# **CONSTRUCTION SUMMARY**

**Kingsmen (Thames) Inc. / Havelock Corners (Kingsmen)**

Lot/Unit: 96 Phase/Building: 4A Model/Floor Plan: Edward (3602) Elev C 4 Bed - 2+1 Bath

### **GROUND FLOOR EL. C**

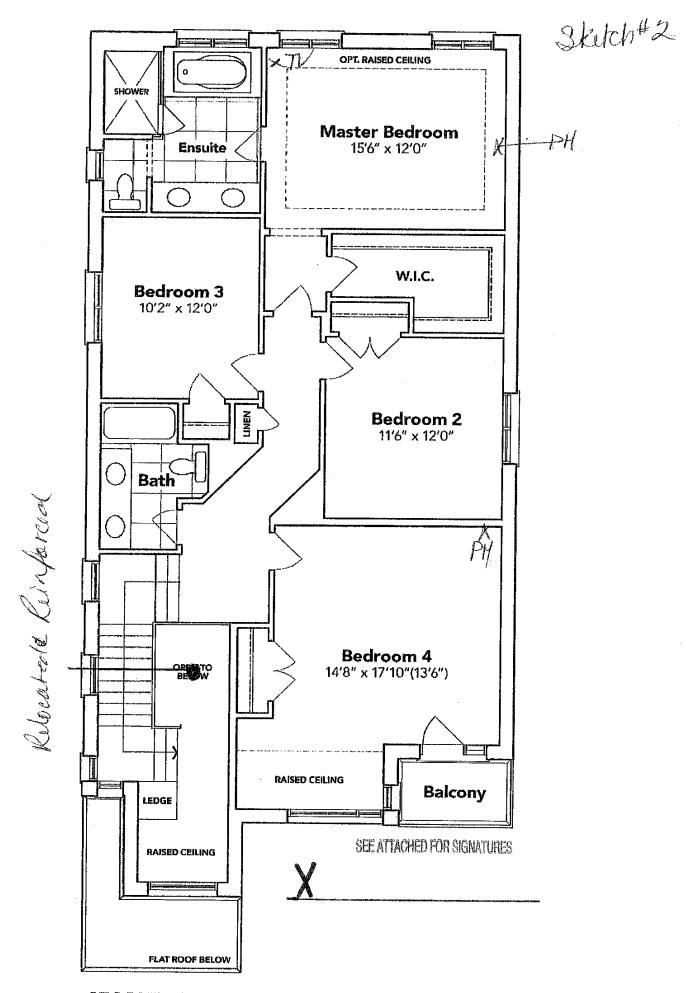
Inv. <b>4570</b>	1 - To supply & install the standard T.V. rough in in the great room and master bedroom see sketch # 1 & # 2	
Line 58237	Note:	
19Mar20 / 24Mar20		
Inv. <b>4570</b>	1 To supply & instant the standard I none rough in in the kitchen, master bedroom and	
	bedroom #4 see sketch # 1 & # 2	
Line 58238	Note:	
19Mar20 / 24Mar20		
Inv. <b>4570</b>	1 - Relcoate the std. ceiling light in the great roomsee sketch # 1	
Line 58239	Note: Have this standard light and standard switch connected to the additional ceiling light in the great room second light sold sep.	
19Mar20 / 24Mar20		
Inv. <b>4570</b>	1 - To supply & install an additional ceiling light in the great room area see sketch # 1	
Line 58240	Note: Have this upgraded light connected to the relocated standard light, both lights on the std. switch.	
19Mar20 / 24Mar20		
Inv. <b>4570</b>	1 - Relocate the standard ceiling light from the upper stair landing to the O.T.B. area on the second floor see sketch # 2
